Waterfront Square, Reading – Daylight & Sunlight

I write in response to the BRE Client Report entitled 'Review of daylight and sunlight assessment at Norman Place, Reading' ("the BRE Report") dated 7th November 2024. The BRE Report reviews the daylight and sunlight reports submitted with planning application PL/24/0958 prepared by GIA, namely the daylight and sunlight report dated 17 July 2024 and the internal daylight, sunlight and overshadowing report dated 17 July 2024 ("GIA's Reports").

This letter responds to the comments made in the BRE Report. Specifically, it addresses the points raised in paragraph 5.1 of that document.

Figure 01 - Proposed Sunlight Amenity to Open Spaces

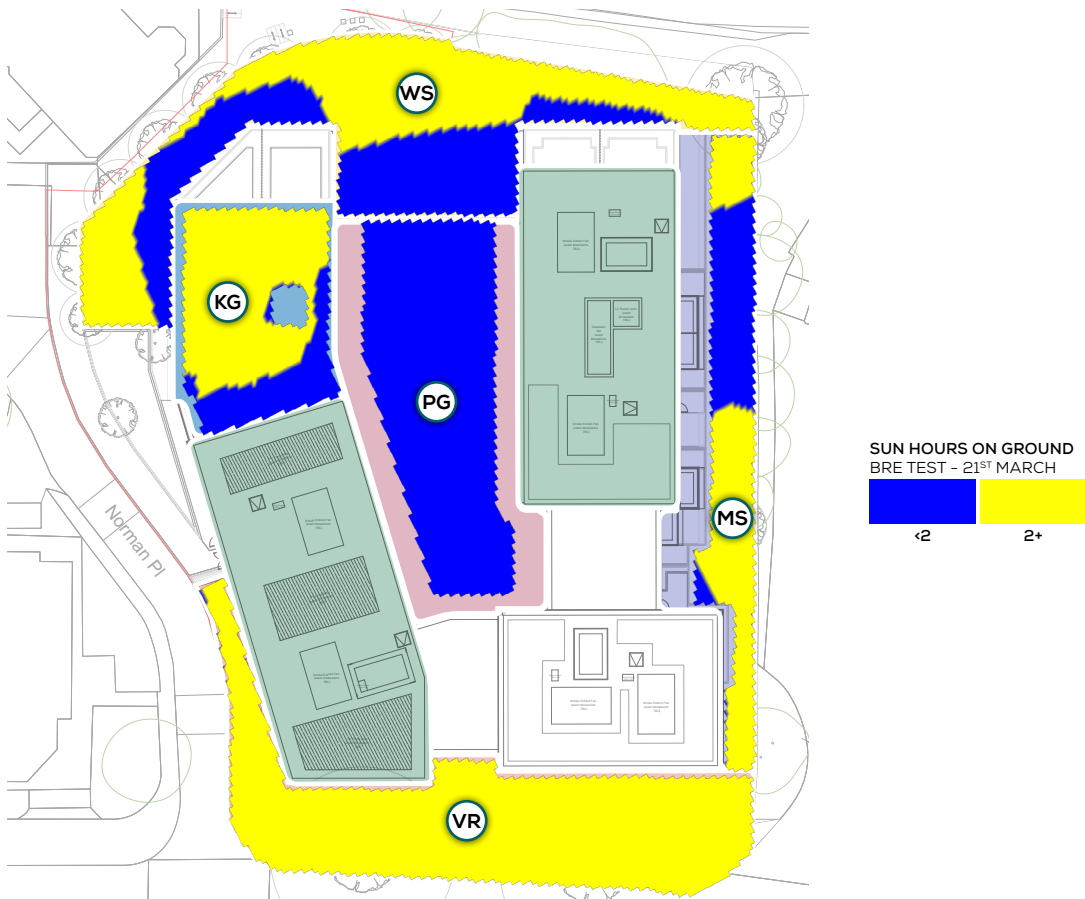
Individual areas of sunlight provision for open spaces to be provided, including the proposed public “Waterfront Square” to be analysed as a separate space

In line with the recommendations in the BRE Report, GIA have carried out further detailed assessments of the proposed areas of open space to demonstrate the compliance of each individual space. The spaces have been defined using the landscape character areas plan, which includes the requested ‘Waterfront Square’ to the north of the development. The landscape plan accompanies this letter within Appendix 04.

The BRE Guidelines recommend that for a proposed open space to be adequately sunlit it should receive at least two hours of sunlight across at least half of its area on 21 March. Table 07 and Figure 01 below present a summary of the compliance results for each individual area and for all areas combined:

Four of the five (80%) proposed open spaces achieve the recommended two hours of direct sunlight to 50% of the area on 21 March. The total compliance for all of the areas combined is 60%. This is a 4% improvement when compared to the findings in the internal daylight, sunlight and overshadowing report dated 17 July 2024. This is because the assessment areas have been redefined to follow the landscape character areas plan, as recommended by the BRE.
